g0-sense — Design Document

ai-ee v1 pipeline
generated 2026-08-27 19:48:25

Board review - g0-sense (P8 verify-reviewer, adversarial pass, 2026-08-27)

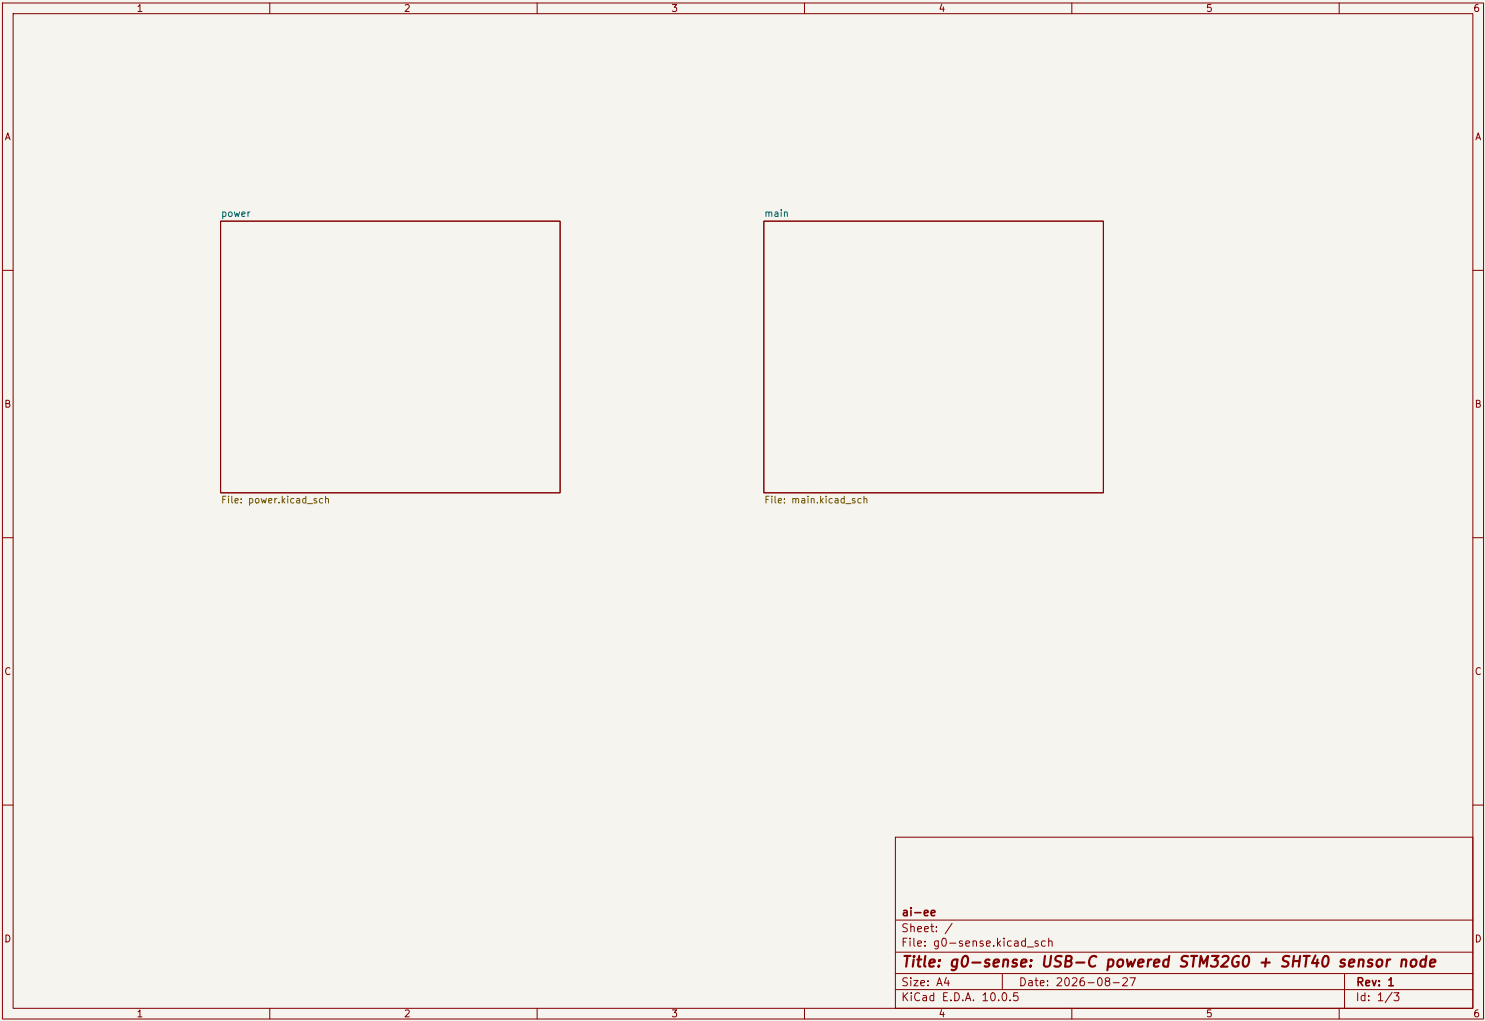
W2 - carried SHT4x VDD-slew verify item - CLOSED as accepted risk

Finding: `power_tree.md` / `decisions.md` carried "verify SHT4x VDD slew <= 20 V/ms vs the AMS1117 startup ramp"; the reviewer found it unclosed, found no slew spec in `parts/C2909890.json`, and computed ~40 V/ms from AMS1117 current-limit charging of the ~27 uF on +3V3.

Closed, no hardware change, on three findings:

1. **Provenance is on file** (the reviewer looked in the wrong artifact). The number is `research/records/sht4x-vdd-slew-power-up.yaml`, sourced to `research/sources/HT_DS_Datasheet.SHT4x.pdf` p9 Table 4, read visually by the researcher and again by a fresh second reader (`maturity: verified`). `parts/C2909890.json` is the P3 extraction, a different artifact with a different scope.

2. **The worst-case number is an upper bound that cannot occur.** I/C (~1 A into ~27 uF) assumes the LDO drives its output cap independently of its input. The AMS1117 is a series-pass follower: on a cold start VOUT cannot rise faster than VIN minus dropout, so the +3V3 edge is set by the USB source's VBUS ramp filtered by C2 = 10 uF, not by the LDO's current limit.

3. **The named failure mode is benign at cold start.** The datasheet says only "faster slew rates MAY lead to a reset" - and the second reader already flagged the researcher's added "or hung until re-powered" as unsupported by any cited page. A reset during the power-up ramp leaves the part in exactly the state a power-up is meant to produce. The limit's real bite is in-operation supply excursions, and hot-plugging a DOWNSTREAM breakout onto an already-live Qwiic rail - that one is the breakout's decoupling problem, not this board's.

Hardware alternatives considered and rejected: a series R at U3 VDD to slow the local ramp is disqualified by the SHT4x on-chip heater (75 mA peak across the ~100 ohm needed for a 100 us tau

= 7.5 V drop); raising C3 past ~50 uF to force I/C under 20 V/ms buys nothing against finding 2 and costs a part change on a green schematic.

Belt and braces, documentation only: "issue an SHT4x soft reset (0x94) at init" (Sensirion's own recommended start-up sequence) goes into the design doc and fab/README, and the Qwiic hot-plug caveat is carried as a known limit of the board.

W3 - J3/J4 DNP intent not KiCad-native - FIXED

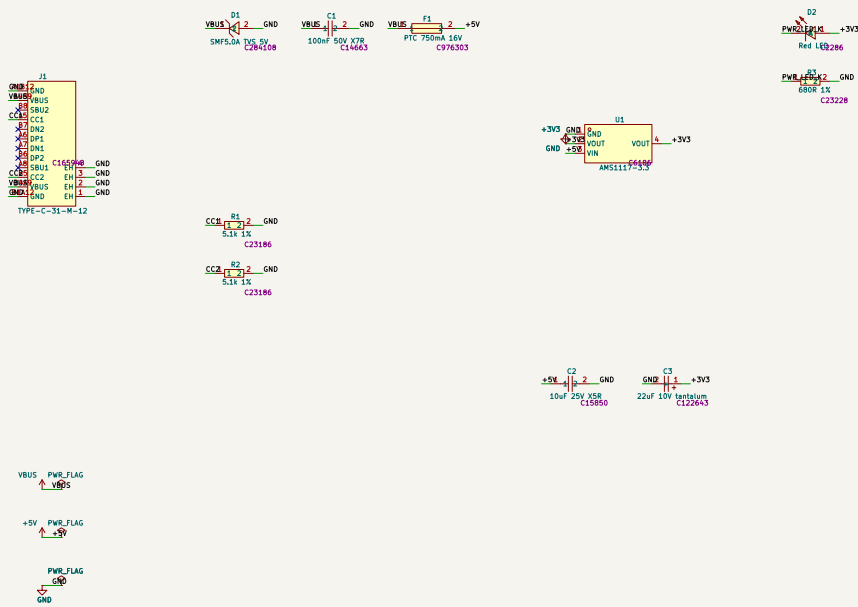
Not waived. The headers carried DNP only in a custom `Variant=DNP` field and the value string, so a native KiCad BOM/POS export would have emitted the two THT headers as populate lines into a JLC economy (SMT-only) order. Dispatched as work order `log/workorders/wo-w3-dnp.json`: native `dnp` attribute set through the board's own generator, and `refdes_class: {J3, J4 -> hand_install}` added to the header line in `parts/parts.json` so `bom.cpl.py` keeps them out of the assembler upload and the CPL while still listing them in the documentation BOM. ERC re-run after the change.

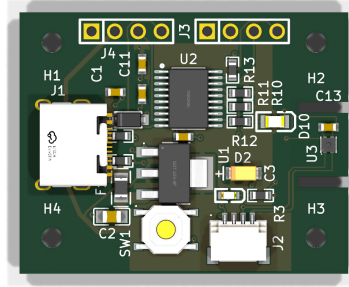
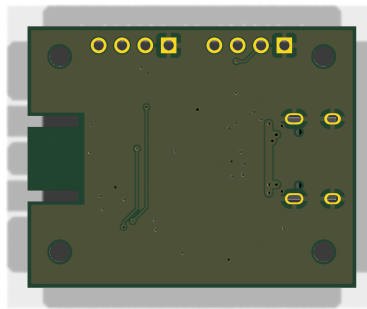
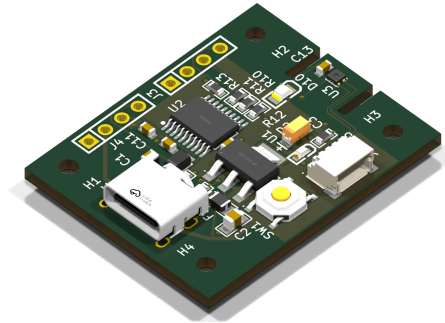
W-1 (warning, silk): J3/J4 per-pin function labels promised by the

architecture are absent blocks.md ("Headers + indicators") promises the SWD and UART headers "silk-labeled per pin" with pin 1 silk-marked. The board delivers refdes J3/J4, a pin-1 square pad plus a silk dot on each - and NO per-pin GND/3V3/SWDIO/SWCLK or GND/3V3/TX/RX labels (verified: the only silk text items on the whole board are refdes plus C3's "+"; see top render, top edge). These are the two headers the owner hand-solders and hand-wires; they are visually identical 1x4 0.1 in headers with the same GND-at-pin-1, 3V3-at-pin-2 convention. Consequence: the mixup that convention was designed to prevent (wiring a UART dongle's 5 V or swapping GND/3V3 by counting pins from the wrong end, or confusing SWD with UART) is left to documentation the bare board does not carry. Cheap fix at P9: eight small text items along the top edge; ample empty silk space exists there. Cross-artifact drift: the architecture REQUIRED this; product scope makes its absence a finding, not a nit.

W-2 (warning, silk): 6 misattributed refdes labels, several of which are

also COVERED by parts after assembly - fix, do not waive check_silk's 6 warnings are all real, and four are worse than the checker says because the text lands where a component body will be:

- R1 (24.82,40.55) and R2 (24.82,42.75): inside J1's shell region (J1 courtyard to x=26.32) - covered by the USB-C shield after assembly AND read as J1's label (top render: text on the connector).
- C10 (36.67,36.00): inside U2's silk body outline (35.51..39.20 x 33.09..39.91) - under the TSSOP after assembly.
- D1 (35.60,42.60): inside U1's silk outline - reads as U1's label; the TVS itself is left with no visible refdes, which is exactly the part a rework tech must not confuse.
- D2 (43.25,42.92): 0.12 mm from C3 - reads as the tantalum's label (top render: "D2" sits over C3, whose own label is off to the right).
- R10 (47.03,35.90): reads as D10's label; D10's own text drifted to (49.98,39.50) at the slot mouth. Related uncounted case: C13's refdes sits at (52.60,36.23), separated from C13 (on the tongue at 52.60,39.60) by the top slot, and it crowds the H2 label.

Consequence: debugging and rework against the silk misidentify parts; assembly itself is unaffected (JLC places from CPL). Severity warning is correct. Disposition: one place_edit.py move_text batch at P9 - silk-only, zero copper risk - NOT a waiver. (Per the rules I did not run silk_place.py or edit anything.)

W-3 (warning, fab): panelization tabs on the sensor tongue edge would

stress the cantilever - put a remark on the JLC order The tongue's outer face (x=54.75, y 38.05..44.95) is a board edge. JLC economy panelizes internally; a break-off tab or mouse-bite row landed on the tongue tip would transmit snap force through the 6.9 mm root while U3 rides the beam. The tongue itself is stubby and strong (5.5 mm long, 6.9 mm wide root, 1.6 mm FR-4 - aspect ratio < 1; it will survive normal handling and depanelization fine), so this is only about where a tab lands. P9 disposition: add the JLC order remark "no break-off tabs / mouse bites on the right-edge sensor tongue (x 49.25-54.75 span)"; the same remark block already owed for the Sensirion no-wash rule (blocks.md B4) is the natural place.
